ACCESSIBILITY ASSESSMENT

DATE OF REPORT:
March 4, 2025

ADA TITLE II ASSESSMENT

Riverbend Elementary School
320 51st Street
Springfield, Oregon 97478

Photos for Barrier ID: AX555513

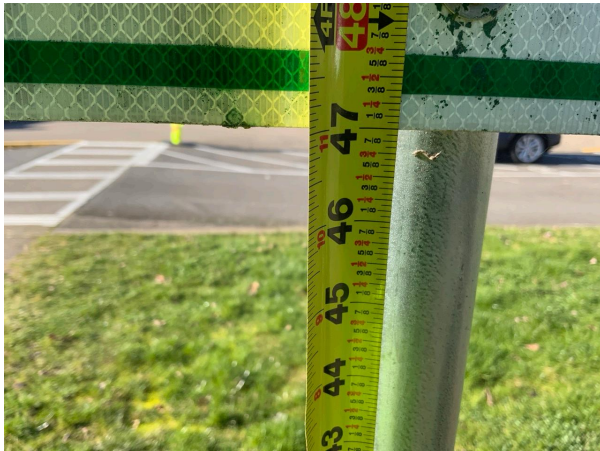
Assembly	Accessible Parking
Type	Parking Space - Car
ADA Standard	Oregon Revised Statutes 447.233-2(e) and 2(f); ADA 502.6
Barrier Detail	OREGON: Signage is not compliant for the standard accessible space.
Location Description	Accessible Parking Space P1-C
Observed	Jan 24, 2025 by Danjo.Ginete@bureauveritas.com
Site Conditions	The bottom of the lowest sign is 45 1/2" above the parking surface.

Provide compliant signage for the standard accessible stall. Install signage showing the International Symbol of Accessibility (ISA) EITHER on a free-standing post mounted minimum 84" (+ or - 3") above the stall surface measured to the bottom of the parking sign OR on a building or pier mounted minimum 60" above the stall surface measured to the bottom of the parking sign. Where signage is located on a free-standing post, the post shall be located at the head of the stall, and 2' minimum from the centerline of the painted lines outlining the sides of the stall. Parking space identification signs shall include the International Symbol of Accessibility, and "Reserved Parking". Where the sign post is mounted on a raised surface which is higher than the stall pavement, the vertical measurement shall be from the stall pavement surface to the bottom of the sign.

Photos for Barrier ID: AX555541

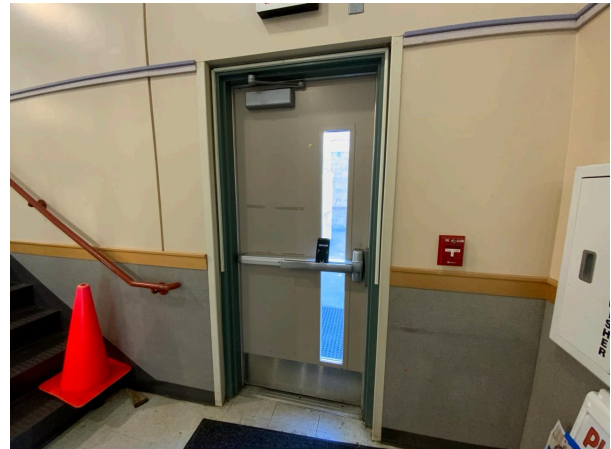
Assembly	Interior Access Route
Type	Door
ADA Standard	404.2.9
Barrier Detail	
The opening force required to open the accessible, hinged, non-fire door is more than 5 pounds.	
Location Description	Cafeteria
Observed	Jan 24, 2025 by Danjo.Ginete@bureauveritas.com
Site Conditions	The opening force is 11 pounds.

Adjust the closer or replace with a door that requires no more than 5 pounds of force for pushing or pulling the door open. The force at the latch, the force to set the door in motion, and the force to fully open the door shall be maximum 5 pounds. These forces do not apply to the force required to retract latch bolts or disengage other devices that hold the door or gate in a closed position.

Photos for Barrier ID: AX555567

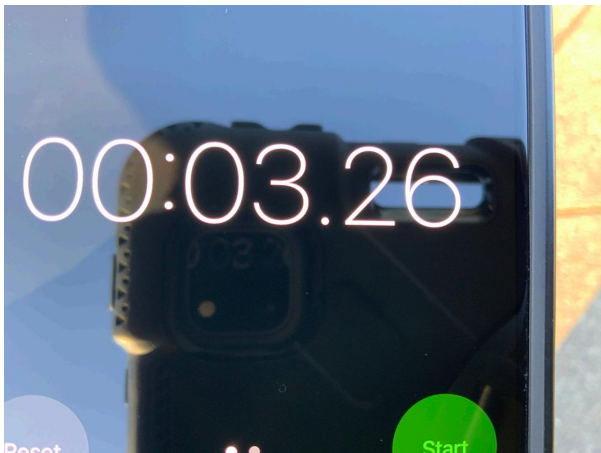
Assembly	Exterior Access Route
Type	Exterior Accessible Route
ADA Standard	403.3
Barrier Detail	The accessible route has cross slopes greater than 1:50 (2%).
Location Description	Gate G-3 to Field
Observed	Jan 24, 2025 by Danjo.Ginete@bureauveritas.com

The walkway should be graded to a maximum 1:50 (2%) cross slope. An accessible route has maximum 1:20 (5%) running slope and maximum 1:50 (2%) cross slope. [EXCEPTION: Cross slopes not exceeding 1:48 (2.08%) are permitted.] The clear width of walking surfaces shall be 36" minimum. [EXCEPTION: The clear width shall be permitted to be reduced to 32" minimum for a length of 24" maximum provided that reduced width segments are separated by segments that are 48" long minimum and 36" wide minimum.] Where grading to maximum running slope of 1:20 (5% running slope) is not possible, provide a compliant ramped surface within the walkway with maximum slope 1:12 (8.33%) and maximum ramp run rise of 6" without handrails. If a ramped surface with running slopes greater than 1:20 (5%) and maximum 1:12 (8.33%) rises more than 6", handrails are required. The cost estimate for this barrier removal is based on grading the running slope to maximum 1:20 (5%). The quantity and order of magnitude cost estimate provided for this barrier are limited to the extent of the area identified as non-compliant. Additional costs that may be associated with removal of the barrier are not included.

Photos for Barrier ID: AX555528

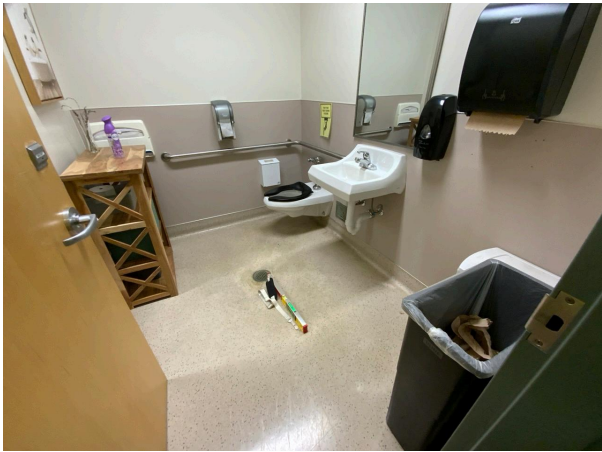
Assembly	Restroom
Type	Restroom/Bathroom - Door
ADA Standard	404.2; Table 404.2.4.1
Barrier Detail	
The pull side of the accessible door does not have the required maneuvering clearances.	
Location Description	Boy's Restroom
Observed	Jan 24, 2025 by Danjo.Ginete@bureauveritas.com
Site Conditions	The trash can is in the required maneuvering clearance at the door.

Relocate waste bin to provide the required maneuvering clearance at the pull side of the door. The required depth of the maneuvering clearance is 60" minimum. The required side clearance is 18" minimum on the latch side of the door. Maneuvering clearance shall extend the full width of the doorway and the required latch side clearance. Floor or ground space within the required maneuvering clearance shall be maximum 1:48 (2.08%) slope. Changes in level are not permitted.

Photos for Barrier ID: AX555556

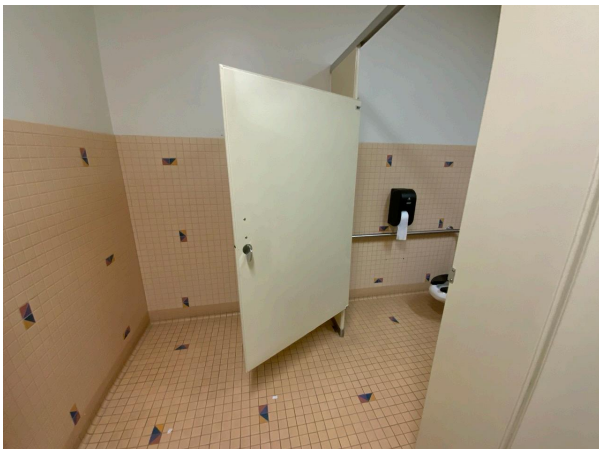
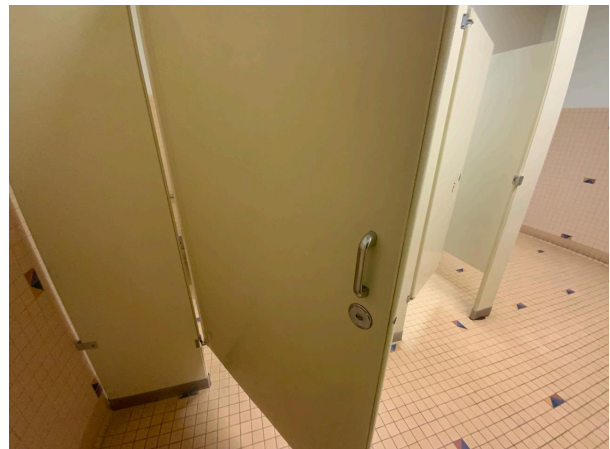
Assembly	Restroom
Type	Restroom/Bathroom - Water Closet
ADA Standard	2009 ANSI A117.1-604.5.1 and A117.1-604.9.6
Barrier Detail	
ANSI A117.1-2009 : A vertical side grab bar is not present in the wheelchair stall.	
Location Description	Boy's Restroom
Observed	Jan 24, 2025 by Danjo.Ginete@bureauveritas.com
Site Conditions	A vertical side grab bar is not present in the wheelchair stall.

Resolution		
Install a vertical side grab bar on side wall closest to the toilet. The vertical grab bar shall measure 18" long minimum, mounted 39" to 41" above finish floor. The centerline of the grab bar shall be between 39" and 41" from the rear wall.		
Quantity	Unit Cost	Total Cost
1 EA	612.38	\$ 612
Priority	3

Photos for Barrier ID: AX555557

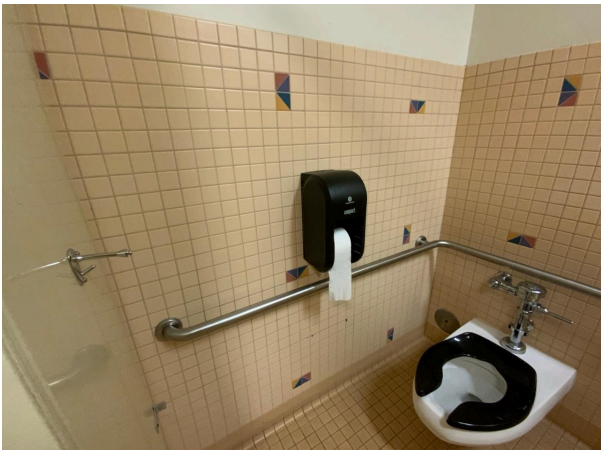
Assembly	Restroom
Type	Restroom/Bathroom - Water Closet
ADA Standard	609.3
Barrier Detail	
The space between the grab bar and projecting objects above the grab bar is less than 12" minimum.	
Location Description	Boy's Restroom
Observed	Jan 24, 2025 by Danjo.Ginete@bureauveritas.com
Site Conditions	The space between the side grab bar and the toilet paper dispenser is 3 1/2".

Move the projecting object above the grab bar to 12" minimum from the top of the gripping surface of the grab bar. [EXCEPTION: The space between grab bars and shower controls, shower fittings, and other grab bars above shall be permitted to be 1-1/2" minimum.]

Photos for Barrier ID: AX555558

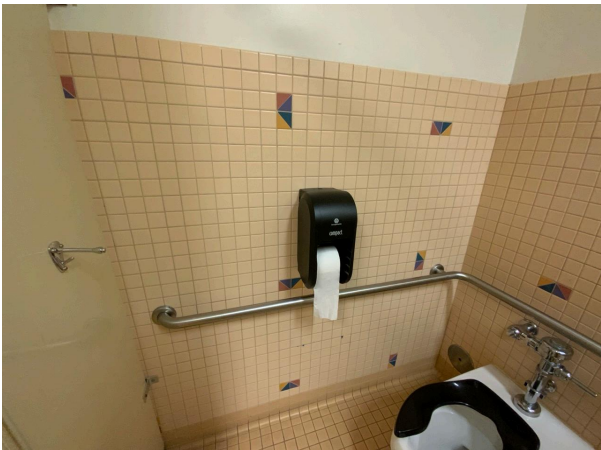
Assembly	Restroom
Type	Restroom/Bathroom - Water Closet
ADA Standard	604.5.2
Barrier Detail	The rear grab bar at the water closet is not compliant.
Location Description	Boy's Restroom
Observed	Jan 24, 2025 by Danjo.Ginete@bureauveritas.com

Remove and install a compliant rear grab bar. The rear wall grab bar shall be 36" long minimum and extend from the centerline of the water closet 12" minimum on the closed side and 24" minimum on the open side. [EXCEPTIONS: 1. The rear grab bar shall be permitted to be 24" long minimum, centered on the water closet, where wall space does not permit a length of 36" minimum due to the location of a recessed fixture adjacent to the water closet. 2. Where an administrative authority requires flush controls for flush valves to be located in a position that conflicts with the location of the rear grab bar, then the rear grab bar shall be permitted to be split or shifted to the open side of the toilet area.] Grab bars shall be installed in a horizontal position, 33" minimum and 36" maximum above the finish floor measured to the top of the gripping surface, except that at water closets for children's use, grab bars shall be installed in a horizontal position 18" minimum and 27" maximum above the finish floor measured to the top of the gripping surface. A continuous grab bar is allowable in lieu of rear and side grab bars. [ADVISORY: It is advisable, but not required, to use the specifications for children where children are the primary users of the restroom. Guidance in applying the specifications for children according to the age group served reflects the differences in the size, stature, and reach ranges of children ages 3 to 12. The specifications chosen should correspond to the age of the primary user group. The specifications of one age group should be applied consistently in the installation of a water closet and related elements. Water Closet Centerline: Ages 3 and 4- 12"; Ages 5 through 8- 12" to 15"; Ages 9 through 12- 15" to 18". Toilet Seat Height: Ages 3 and 4- 11" to 12"; Ages 5 through 8- 12" to 15"; Ages 9 through 12- 15" to 17". Grab Bar Height: Ages 3 and 4- 18" to 20"; Ages 5 through 8- 20" to 25"; Ages 9 through 12- 25" to 27"; Dispenser Height: Ages 3 and 4- 14"; Ages 5 through 8- 14" to 17"; Ages 9 through 12- 17" to 19"].

Photos for Barrier ID: AX555559

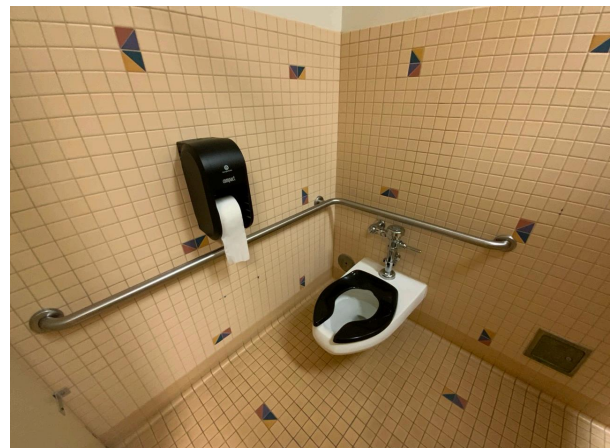
Assembly	Restroom
Type	Restroom/Bathroom - Door
ADA Standard	404.2; Table 404.2.4.1
Barrier Detail	
The pull side of the accessible door does not have the required maneuvering clearances.	
Location Description	Girl's Restroom
Observed	Jan 24, 2025 by Danjo.Ginete@bureauveritas.com
Site Conditions	The trash can is in the required maneuvering clearance at the door.

Relocate waste bin to provide the required maneuvering clearance at the pull side of the door. The required depth of the maneuvering clearance is 60" minimum. The required side clearance is 18" minimum on the latch side of the door. Maneuvering clearance shall extend the full width of the doorway and the required latch side clearance. Floor or ground space within the required maneuvering clearance shall be maximum 1:48 (2.08%) slope. Changes in level are not permitted.

Photos for Barrier ID: AX555553

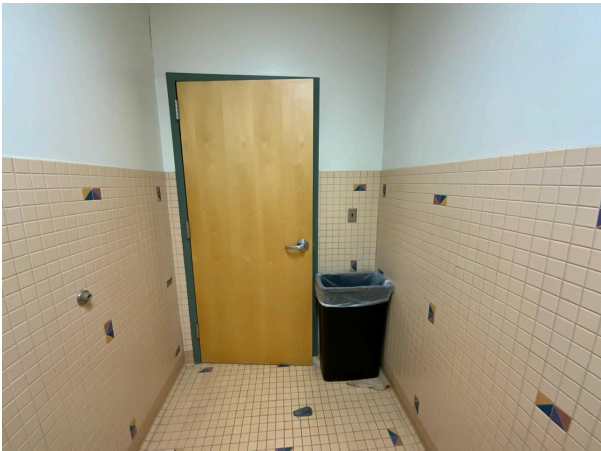
Assembly	Restroom
Type	Restroom/Bathroom - Toilet Stall
ADA Standard	309, 404.2.7, 604.8.1.2
Barrier Detail	The wheelchair stall door is not compliant.
Location Description	Girl's Restroom
Observed	Jan 24, 2025 by Danjo.Ginete@bureauveritas.com

Toilet compartment doors for wheelchair stalls, including door hardware, shall comply except that if the approach is to the latch side of the compartment door, clearance between the door side of the compartment and any obstruction shall be 42" minimum. Doors shall be located in the front partition or in the side wall or partition farthest from the water closet. Where located in the front partition, the door opening shall be 4" maximum from the side wall or partition farthest from the water closet. Where located in the side wall or partition, the door opening shall be 4" maximum from the front partition. The door shall be self-closing. A compliant door pull shall be placed on both sides of the door near the latch. Toilet compartment doors shall not swing into the minimum required compartment area, 60" wide minimum measured perpendicular to the side wall, and 56" deep minimum for a wall hung water closet or 59" deep minimum for a floor mounted water closet measured perpendicular to the rear wall.

Photos for Barrier ID: AX555546

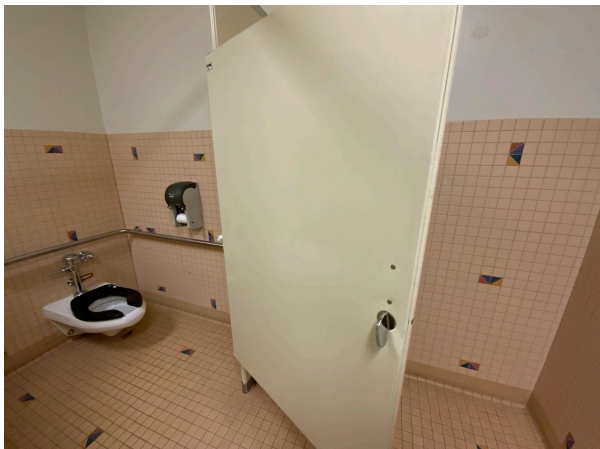
Assembly	Restroom
Type	Restroom/Bathroom - Water Closet
ADA Standard	609.3
Barrier Detail	
The space between the grab bar and projecting objects above the grab bar is less than 12" minimum.	
Location Description	Girl's Restroom
Observed	Jan 24, 2025 by Danjo.Ginete@bureauveritas.com
Site Conditions	The space between the side grab bar and the toilet dispenser is 3 3/4".

Photos for Barrier ID: AX555533

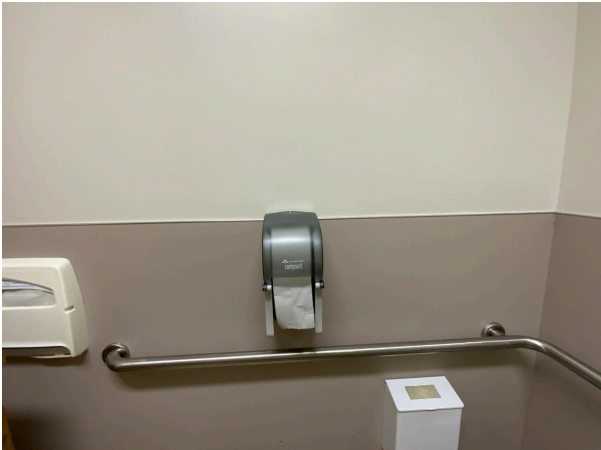
Assembly	Interior Access Route	
Type	Drinking Fountain/Water Cooler	
ADA Standard	602.2	
Barrier Detail		
A clear space is not positioned at the lower level drinking fountain for a forward approach and centered on the unit.		
Location Description	Near Breakroom	
Observed	Jan 24, 2025 by Danjo.Ginete@bureauveritas.com	
Site Conditions		
For a forward approach, the centerline of the drinking fountain is 12.5" measured perpendicular from the side wall.		
Width	12 1/2"	
Resolution		
Install the accessible drinking fountain(s) at a location with a clear space positioned at the drinking fountain for a forward approach and centered on the unit. Clear space shall be minimum 30" by minimum 48", with the 30" dimension centered on the lower level drinking fountain. Clear space shall slope maximum 2.08% in all directions and be a firm and stable surface. [EXCEPTION: A parallel approach shall be permitted at units for children's use where the spout is 30" maximum above the finish floor or ground and is 3-1/2" maximum from the front edge of the unit, including bumpers.]
